UNITED STATES PATENT AND TRADEMARK OFFICE

APPLICATION NO.	FILING DATE	FIRST NAMED INVENTOR	ATTORNEY DOCKET NO.	CONFIRMATION NO.
10/510,424	04/04/2005	Dominique Sebillé	17170/002001	8851
22511 7590 01/23/2007 OSHA LIANG L.L.P. 1221 MCKINNEY STREET SUITE 2800 HOUSTON, TX 77010			EXAMINER TIBBITS, PIA FLORENCE	
			ART UNIT 2838	PAPER NUMBER
SHORTENED STATUTORY PERIOD OF RESPONSE 3 MONTHS		MAIL DATE 01/23/2007	DELIVERY MODE PAPER

Office Action Summary

DETAILED ACTION

**FIG. 3A**

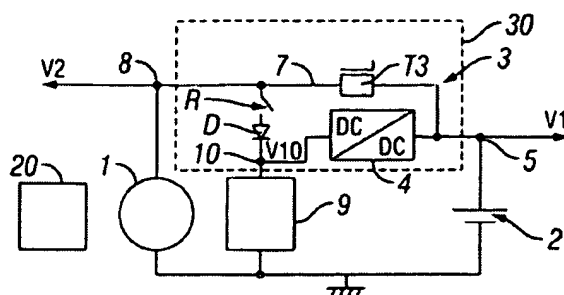
2. The drawings are objected to because element 20, in amended fig.3A, is shown non-connected.

Corrected drawing sheets in compliance with 37 CFR 1.121(d) are required in reply to the Office action to avoid abandonment of the application. Any amended replacement-drawing sheet should include all of the figures appearing on the immediate prior version of the sheet, even if only one figure is being amended. The figure or figure number of an amended drawing should not be labeled as "amended." If a drawing figure is to be canceled, the appropriate figure must be removed from the replacement sheet, and where necessary, the remaining figures must be renumbered and appropriate changes made to the brief description of the several views of the drawings for consistency. Additional replacement sheets may be necessary to show the renumbering of the remaining figures. Each drawing sheet submitted after the filing date of an application must be labeled in the top margin as either "Replacement Sheet" or "New Sheet" pursuant to 37 CFR 1.121(d). If the examiner does not accept the changes, the applicant will be notified and informed of any required corrective action in the next Office action. The objection to the drawings will not be held in abeyance.
